January 16, 2018

Ref: 13810.00

Re: Response to Comments  
BSC Group, Inc. Transportation Engineering Peer Review  
Robsham Village, 462-466 East Main Street  
Milford, Massachusetts

### **Supplemental Crash Data**

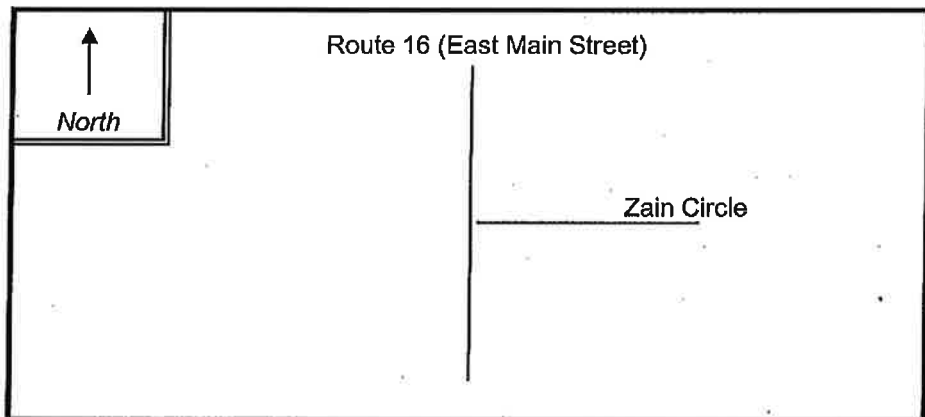
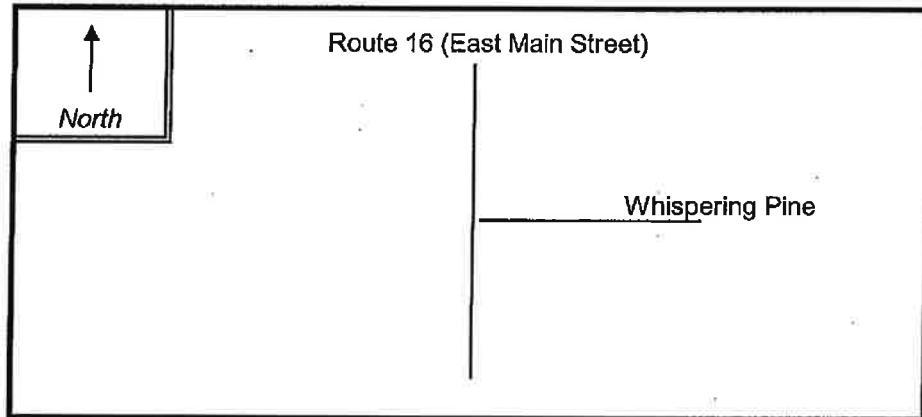
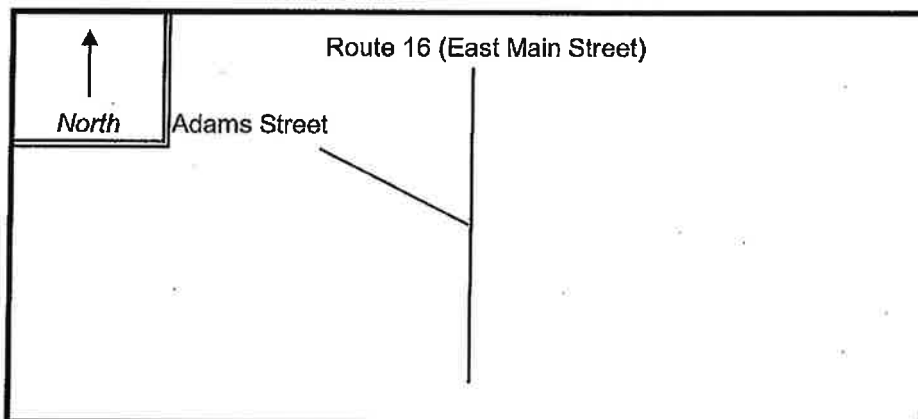
**BSC COMMENT #4 ~ The TIAS provides crash information for the intersection of East Main Street at Fortune Boulevard / Beaver Street. The report also summarizes the segment crash information along Route 16 between I-495 and Adams Street. BSC Group requests intersection crash information at the remaining study area intersections, including the intersections of Route 16 at Zain Circle, Whispering Pine Drive, and Adams Street. Crash rates should be calculated for these locations and compared to the MassDOT District and statewide averages.**

APPLICANT RESPONSE ~ *VHB has provided the crash data requested in summary table format for the three intersections noted as Attachment #1. As presented, none of these locations has exhibited a significant number of crashes during the most recent 5 years of data available and none exceed the MassDOT district or statewide averages for comparable locations.*

### **Supplemental Trip Generation Data**

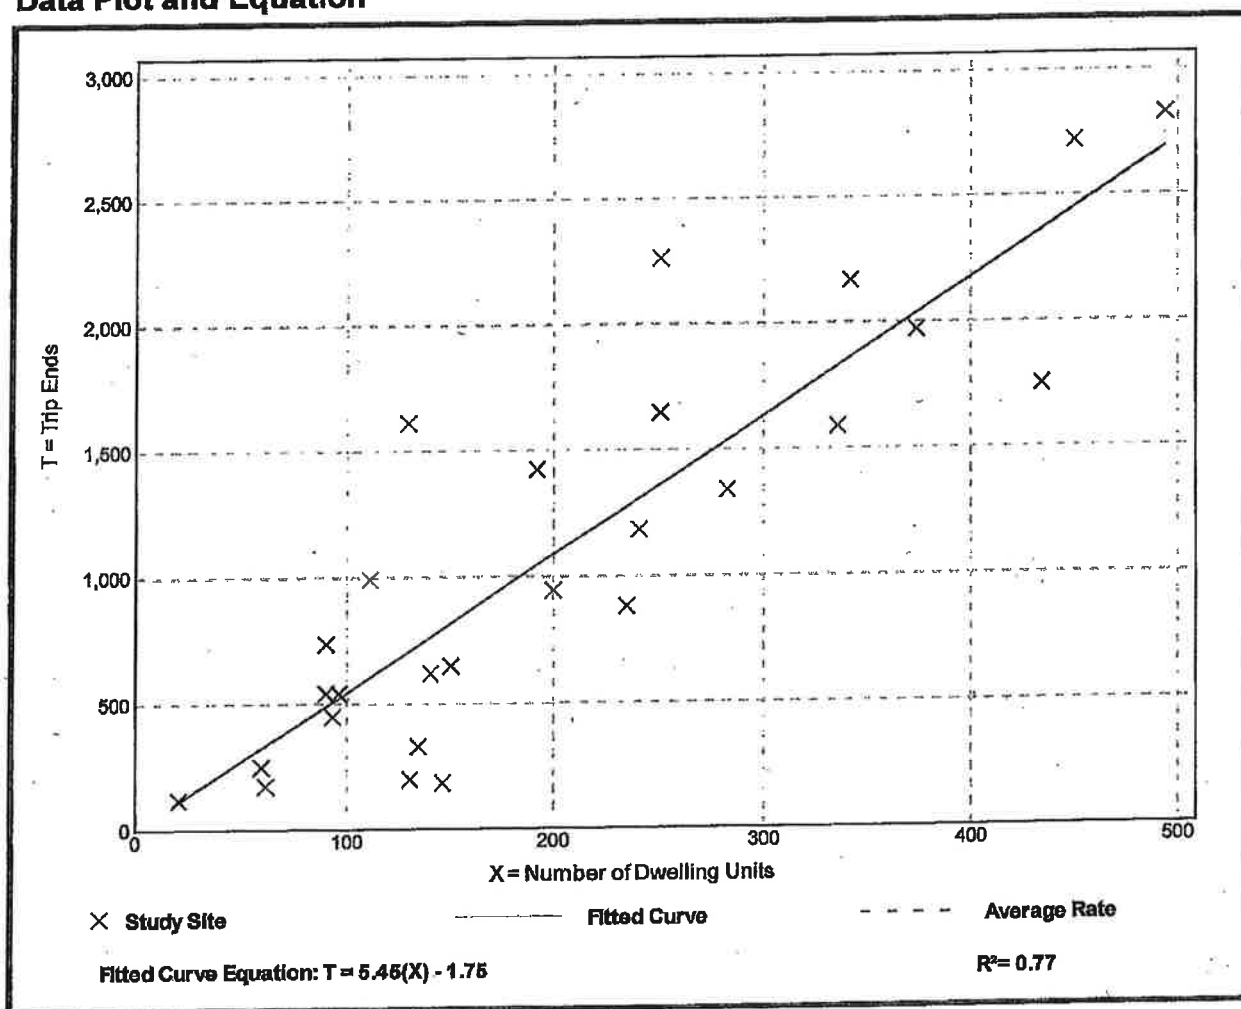
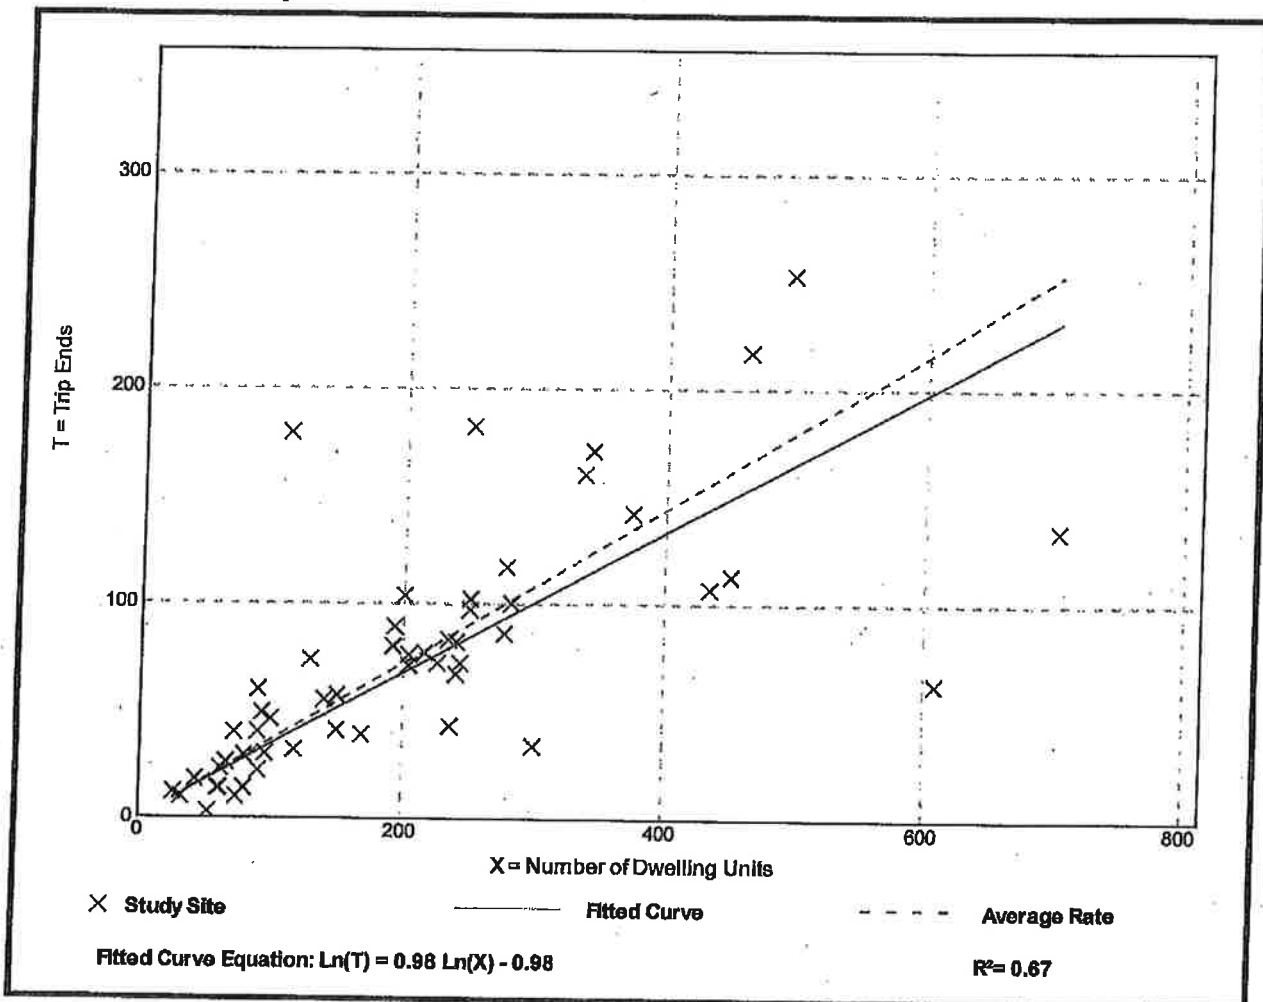
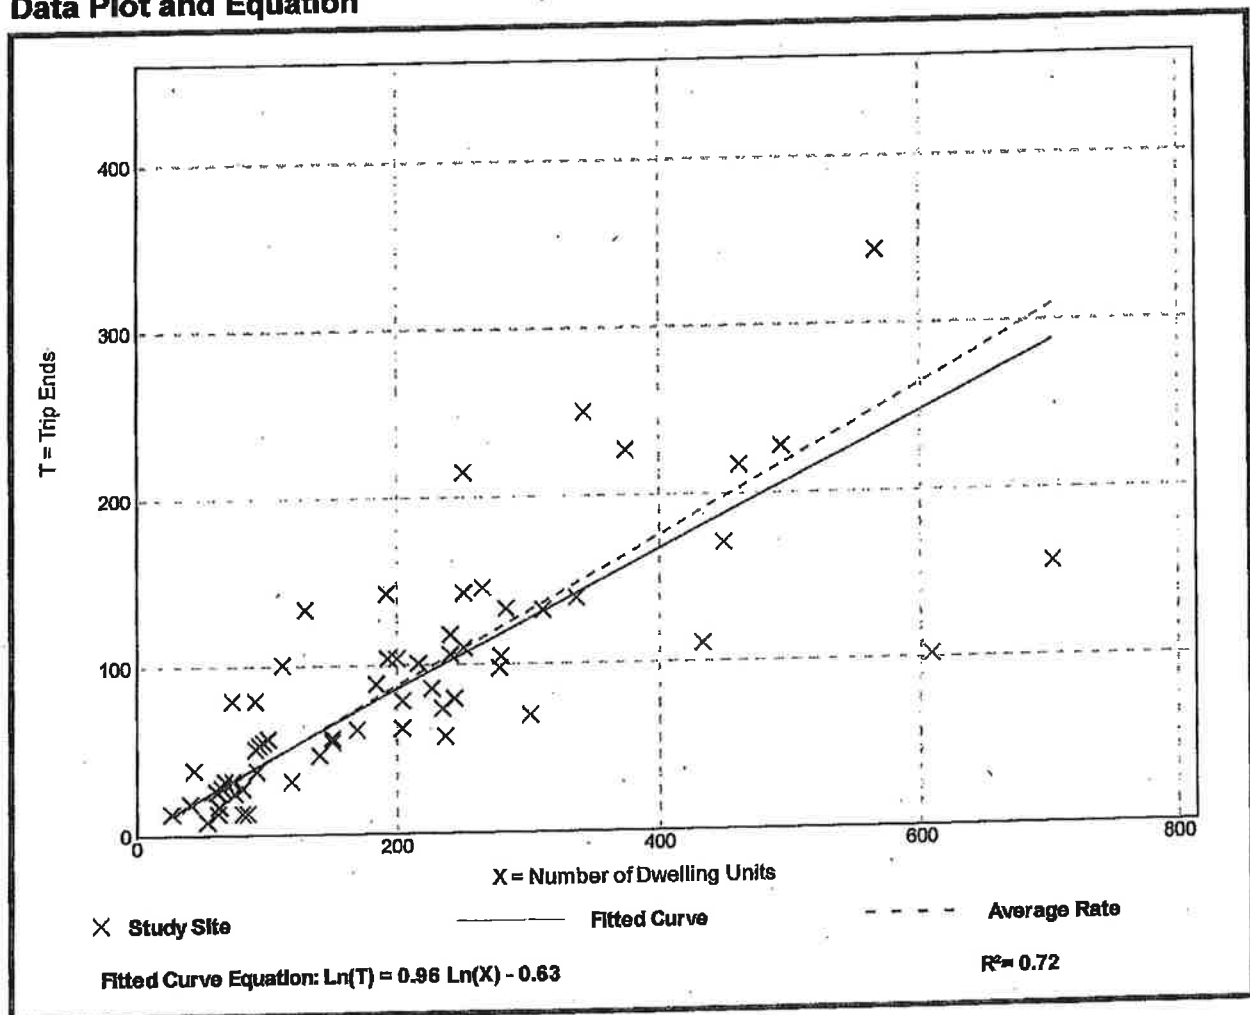
**BSC COMMENT #8 ~ Table 3 summarizes the estimated number of vehicle trips for the proposed development. Trips for the proposed development were estimated using rates from the Institute of Transportation Engineers (ITE) Trip Generation, which is the standard methodology used by traffic engineers to estimate trips, when specific site-development volumes are not available. Since the preparation of the TIAS in July 2017, ITE has released the 10th edition of the Trip Generation Manual. BSC Group recommends comparing the estimated number of trips for the proposed development using the rates included in the 10th edition.**

APPLICANT RESPONSE ~ *The analysis was conducted as requested and is presented in the attachments to this letter as Attachment 2.*

*The one significant difference between the ITE's Trip Generation 9<sup>th</sup> and 10<sup>th</sup> editions is how the data was grouped for different uses. Under the 9<sup>th</sup> edition, the generic land use code 220/apartments was used to capture all residential rental units (apartments). The 10<sup>th</sup> edition changed that description stating that there was no difference between a rental unit (traditional apartment) and an owner-occupied unit (townhouse/condominium).*

*The Proposed 300-unit Project was reclassified in the ITE 10<sup>th</sup> edition to Land Use Code 221/mid-rise multifamily housing (meaning it had between three and ten stories of height to it). The comparison is as follows:*

*Clearly, the change in ITE Trip Generation manuals suggests that there would be a significant reduction in overall trips due to the reclassification of the uses. The analysis in the TIAS was based on the 9<sup>th</sup> edition results and, therefore represents a conservative (worst-case) scenario when evaluating project impacts on the surrounding roadway network.*

### **Signal Warrant Spreadsheets**

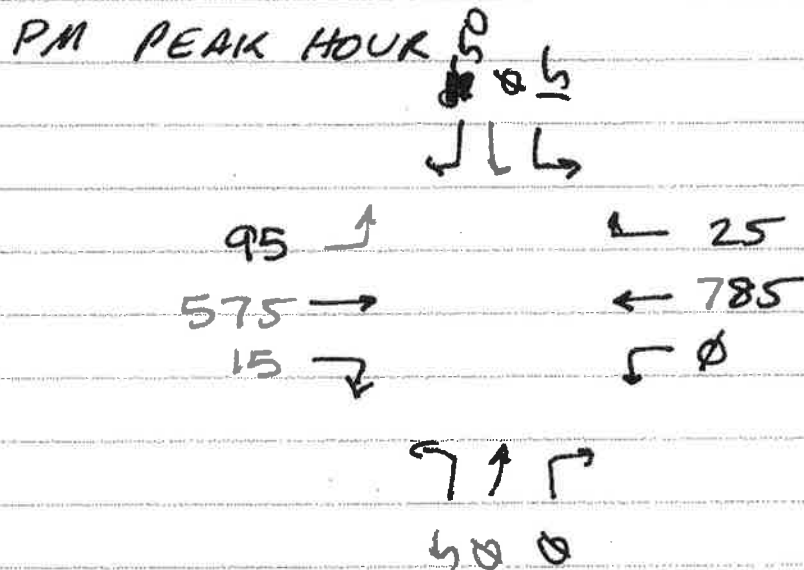
**BSC COMMENT #18 ~ Signal warrant analyses were conducted based on the future Build condition volumes. Please provide additional information as to how the 8-hour Build condition volumes were projected.**

**BSC COMMENT #19 ~ The TIAS indicates that the signal warrant analysis worksheets are included in the Appendix. This information appears to be missing; please provide.**

*APPLICANT RESPONSE ~ The Signal Warrant spreadsheets are attached to this letter as Attachment #5. The 8-hour warrant was determined using the daily trip generation estimate for the project site and having the temporal distribution of residential traffic as noted in the Trip Generation Handbook over the course of a typical day. Using this information and the results of the ATR data collected along the corridor, the signal warrant assessment was conducted. The results indicate that the 8-hour traffic warrants were not met.*

*APPLICANT RESPONSE ~ The Signal Warrant spreadsheets are attached to this letter as Attachment #5.*
